Technical Report

BRGM/RP-72902-FR

CEA/DEHT/LV/2023-100

Analysis of the JRC Harmonized rules for the calculation of Carbon Footprint of Electric Vehicle Batteries

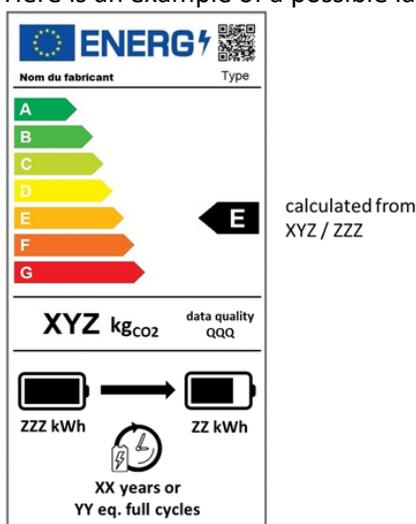
Therefore, we propose the functional unit « produce [and recycle] 1 unit of battery » and 3-fold labelling:

- **Total carbon footprint for 1 unit of battery**
- **Battery certified lifetime in years *and* full cycles equivalent (first limit reached)**
- **Initial SOCE and SOCE at end of life**

Here is an example of a possible labelling (in addition to other requirements of the regulation):

Annex II: Functional Unit shortcomings

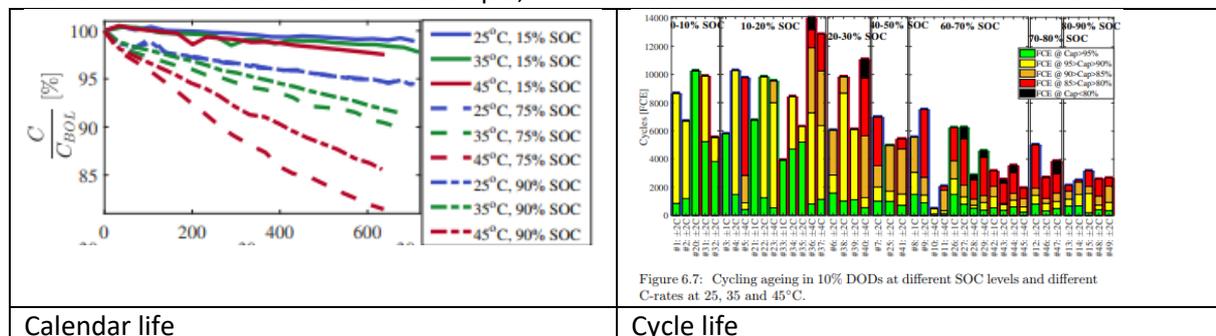
The main shortcoming of the calculation of kWh delivered by the battery using GTR22 is the assumption that the battery is linked to a vehicle that is known at date of manufacturing, and which usage is known as well. It may be less and less the case.

For example, EP tender proposes tenders with included batteries that are used as range extenders for vehicles during their long trips. The same battery can be used to power a variety of vehicles, and also used to provide services to the electricity network while it is not in use for vehicles.

Battery swapping is experiencing a second breath: Nio performed 60 000 swaps in one day and installs 1000 swapping station in China this year. An interesting variation is module swapping (Ample, CATL, and seriously considered by some EU car manufacturers), where modules are added or removed from the car in a few minutes. The same module can power a large car or a small car, the same car can run with different number of modules depending on the forecasted trip. **The conversion between km and kWh at module level is completely impossible** in the case of module swapping.

Annex IV: End-of-Life and Recycling

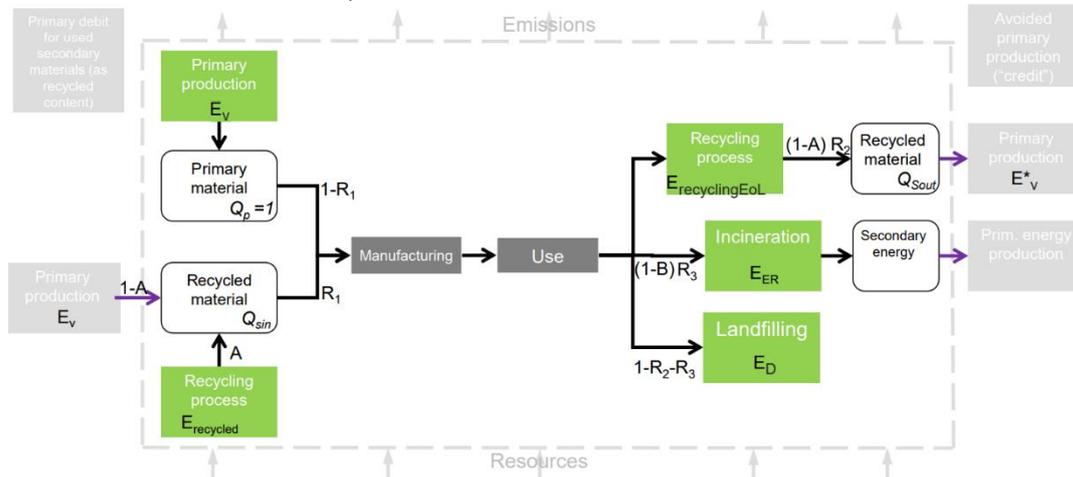
JRC proposes to use the Circular Footprint Formula (CFF) with $A=0.2$

1. Limitations caused by $A = 0.2$

- Recycling process at end of life is largely undefined at time of battery production.
